HIDEOUT, UTAH PLANNING COMMISSION REGULAR MEETING AND PUBLIC HEARING (RESCHEDULED) December 16, 2024 Agenda

Re: Proposed Changes to the Hideout Municipal Code, Titles 8, 9, and 10

Date: December 16, 2024 Planning Commission Meeting

The proposed road section:

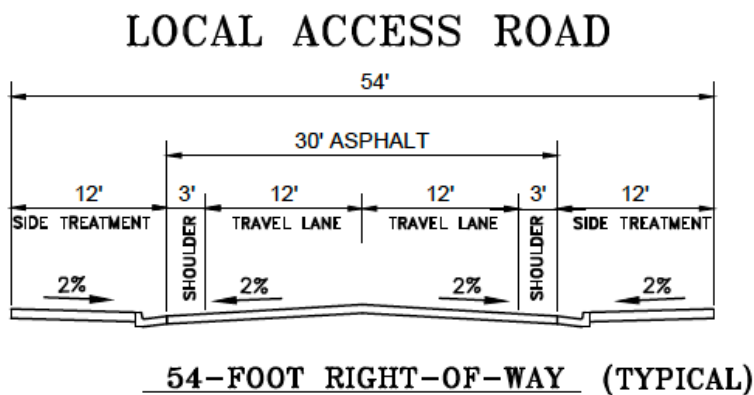
Most of the Town's Engineering Standards will remain essentially the same and will generally be relocated in the new Standard Specifications and Drawing Manual. However, the Town Planner and Engineer would like the Planning Commissioners to specifically look at the newly proposed road widths which are slightly wider than current standards. In addition, the Planning Commission should review and discuss curbs for streets. Historically, the Town has required a rolled curb and gutter, which is essentially a slightly sloped gutter that helps to direct stormwater. The Standard Specifications and Drawing Manual currently detail a high-back curb (i.e., a 6" high curb that cannot be traversed in a car) that requires defined curb cuts for driveways.

A typical road section to date (from the Shoreline Development plan set):

The Planning Commission should review the roads and curbs, in particular, and provide direction and forward a recommendation to the Town Council for these, and all, proposed changes to the Hideout Municipal Code.

Exhibit A, following this page, provides a visual comparison for local, minor collector and major collector roads.

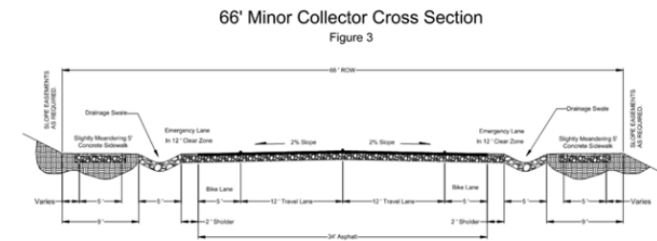
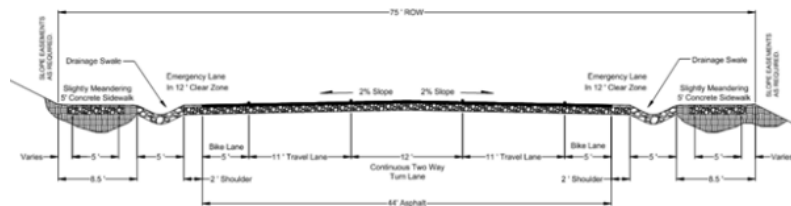
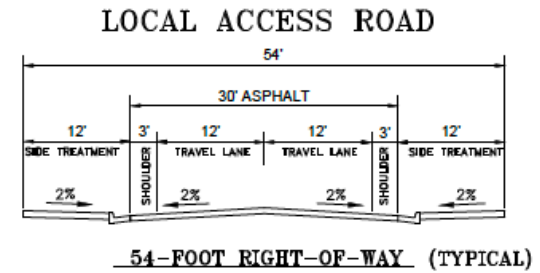
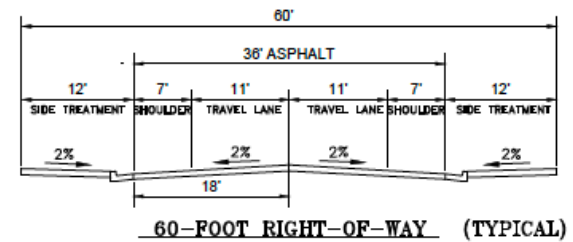
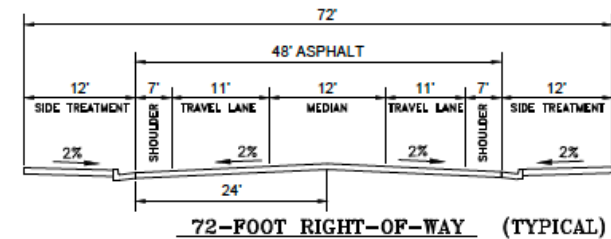
Current Standards

From Shoreline Submittals for Phase 3

Proposed Standards

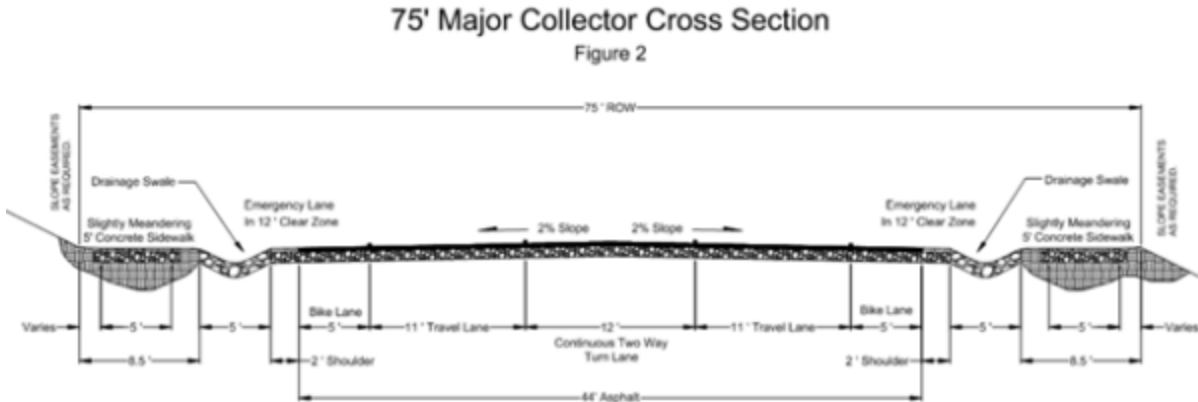
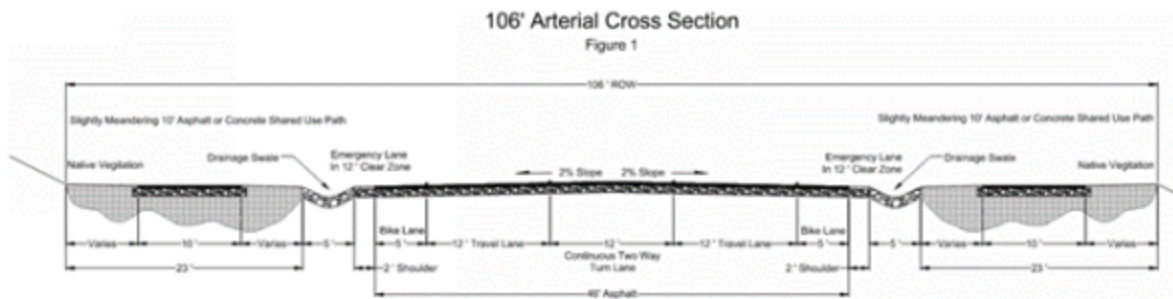
- G. A geotechnical report including pavement design shall be submitted. The thickness of 1 or more of the pavement components shall be increased as needed to achieve the required strength as specified in the geotechnical report approved by the Town Engineer. **REPLACED BY ST-6**

- H. The primary street of an intersection shall not exceed the maximum centerline grades as allowed for each of the roadway functional classifications. Stop-controlled secondary intersecting grades must not exceed the reduced approach values as given in this table. The intersection centerline approach grades of the secondary or intersecting street must exceed at least 100 feet beyond the edge of the paved traveled way of the outside lane of the primary through street before exceeding these values. **REPLACED BY TABLE 5**
